**Annexure-1: Amendment to Tender IISERM (1396)20/21-Pur**

### **Answers to queries received through emails and pre-bid meeting - Tender IISERM (1396)20/21-Pur**

Annexure - 3: Layout; IISERM (1396)20/21-Pur

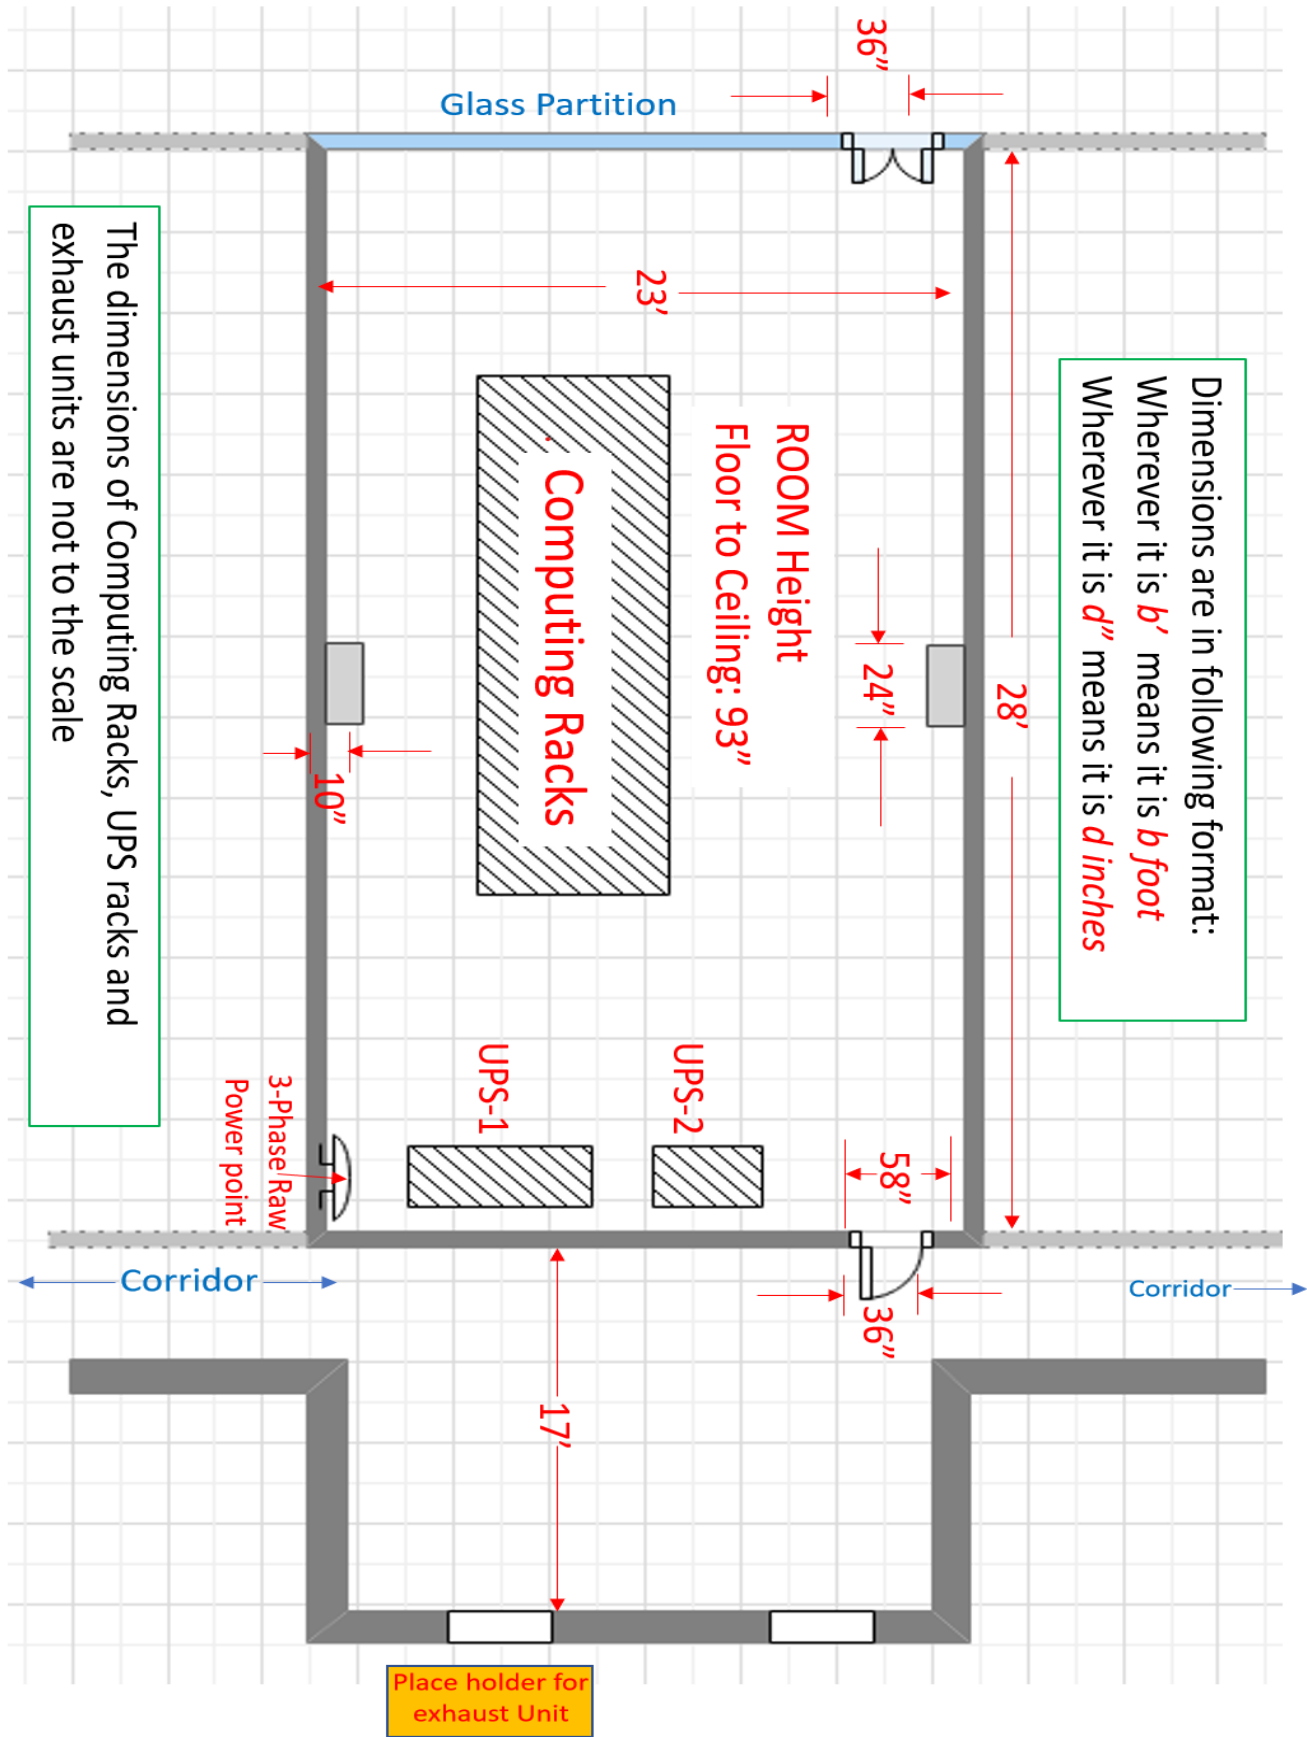
4	16 / 12/ Racks	Must be UL-Certified R-410A Coolant based, with a minimum cooling capacity of 35 kW cooling and minimum 4900 CFM considering 140 CFM per kW	Kindly clarify whether we need to consider room based perimeter cooling or closed couple/inrow cooling which would be installed next to server racks	Closed couple in row cooling solution with units installed adjacent to the racks. Please refer to the

11	General		Kindly clarify the location of batteries as Batteries would require cooling and temperature of 25 degrees for warranty support	Please see schematic diagram (Annexure-3). Further, the bidders are welcome to visit the site before placing their bids.
12	General		Kindly clarify the location of UPS if it has to be placed outside the Rack as 40 KVA UPS would generally installed in Utility Cabinet and does not occupy any U Space	Please check layout Annexure - 3.
13	General		Can we propose 40 KVA UPS and 10 minutes battery installed inside Utility cabinet which shall help in space optimization	No. Battery packs and UPS units are to be installed separately. Please refer to Annexure-I.
14	General		kindly clarify if Fire detection system is to be considered for the Integrated solution	There must be provision for future adaption & integration of fire alarm

and suppression system. It is not necessary as of now.
15	General		Kindly clarify the location of outdoor units for cooling units and approximate distance between indoor and outdoor units	Please check Annexure - 3 for dimensions
16	General	Payment terms as mentioned in the tender	Very long period for release of payment - 3 months	Please comply and please check Annexure-I
17	General	Bank Guarantee clause	GoI rules	GoI/GFR rules are followed, performance security may be read as 3% in place of 10%. Please check Corrigendum

schematic layout diagram in Annexure-3.
5	16 / 12/ Racks	Must be UL-Certified R-410A Coolant based, with a minimum cooling capacity of 35 kW cooling and minimum 4900 CFM considering 140 CFM per kW	For closed couple/inrow cooling considering high density applications CFM required for IT devices in general would be 100 CFM to 110 CFM, request to clarify the same	Please check Annexure-1
6	16 / 12/ Racks	Must be UL-Certified R-410A Coolant based, with a minimum cooling capacity of 35 kW cooling and minimum 4900 CFM considering 140 CFM per kW	Kindly clarify if we have consider any redundancy for cooling units	Please check Annexure-1
7	17 / Racks	Must include Standalone Ultrasonic Rodent Repeller one per rack	Kindly clarify whether we need to consider rodent system for complete room or only rack, it is recommended to consider for complete room and cables shall enter rack from outside the cabinet.	Rodent repellent system is necessary for the complete room as well as for individual racks. Please check Annexure-1
